MIL-C-6521 (USAF)
AMENDMENT 2
8 September 1959
Superseding
AMENDMENT 1
16 February 1956

MILITARY SPECIFICATION

CONTROL, INVERTER CHANGEOVER, TYPE A-2

This amendment forms a part of Military Specification MIL-C-6521 (USAF) dated 18 September 1951.

FIG 1
CONTROL-INVERTER CHANGE OVER
TYPE A-2 AUTOMATIC

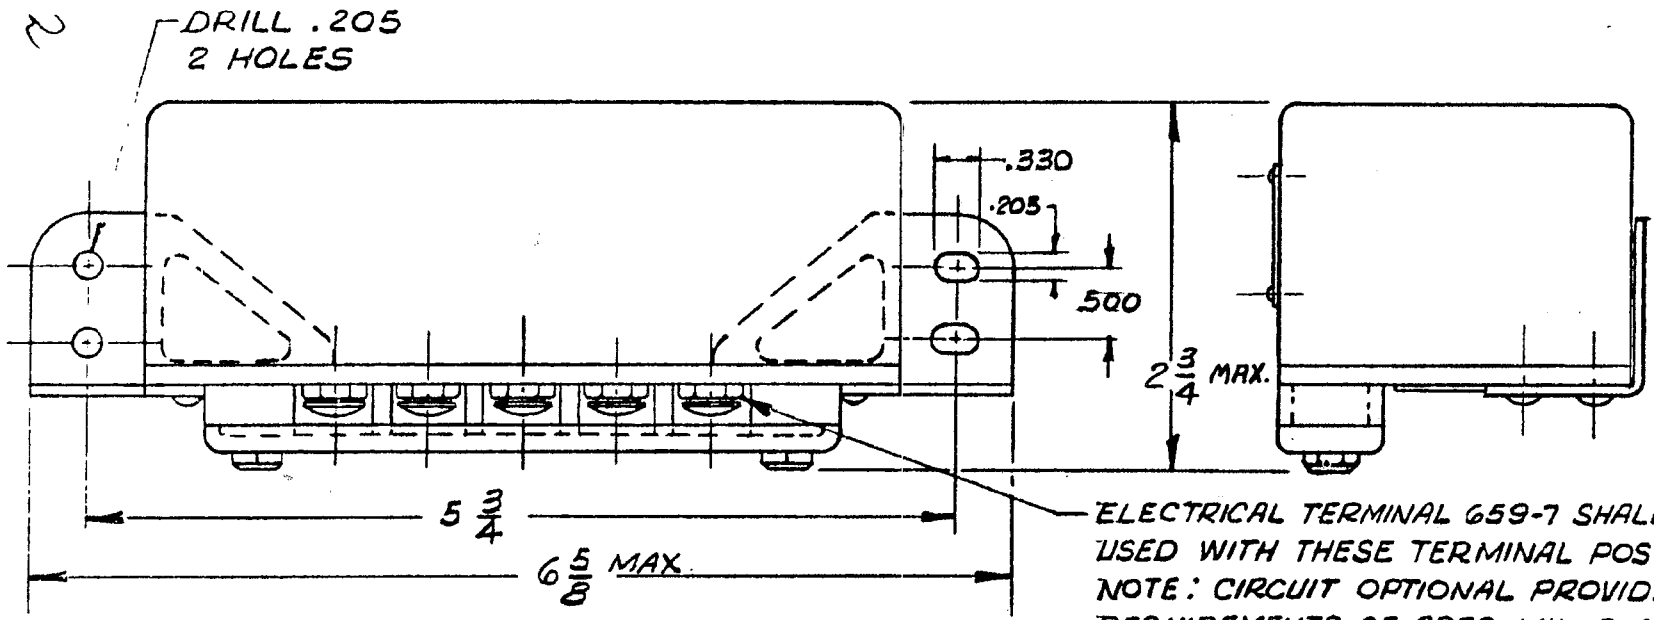
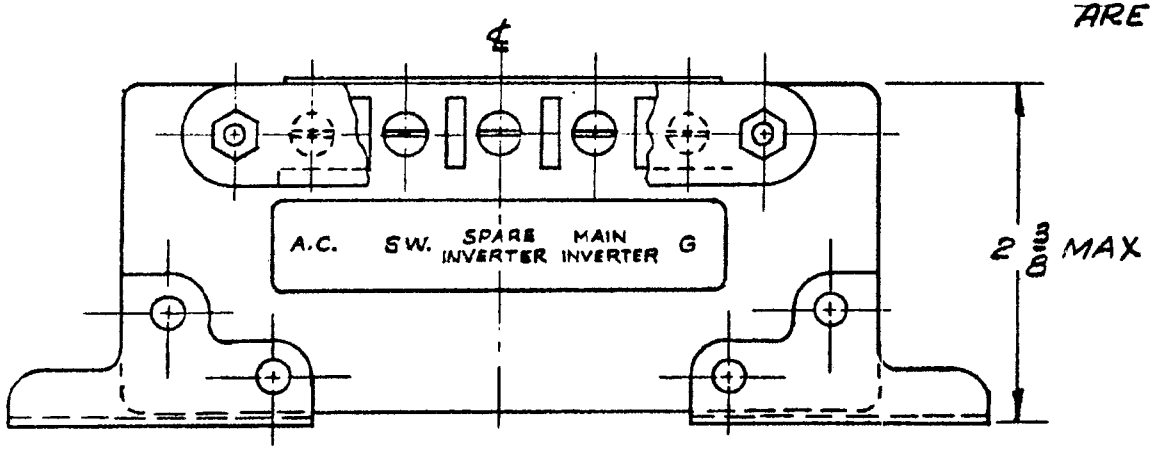
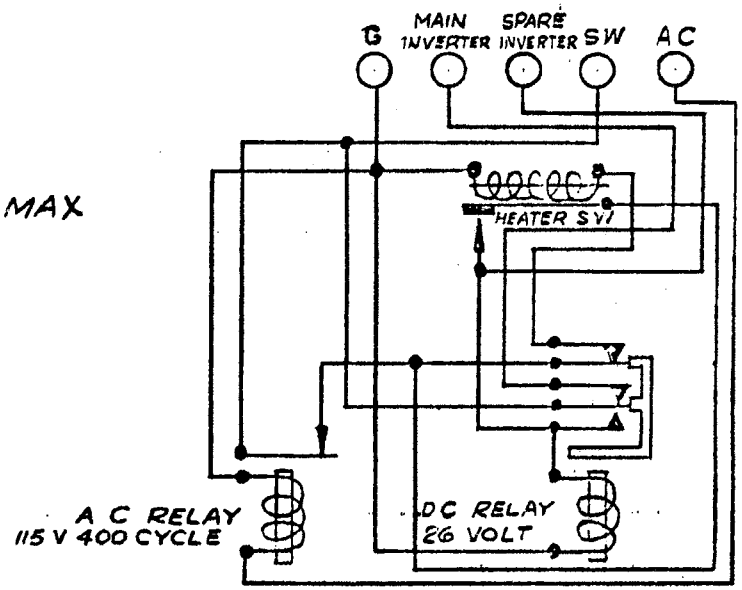
Page 3, paragraph 3.3.2: Delete "Drawing No. 45B7367" and substitute "figure 1."

Add figure 1. Figure 1 forms page 2 of this amendment.

Page 4, paragraph 3.10, line 2: Delete "Drawing No. 45B7367" and substitute "figure 1."
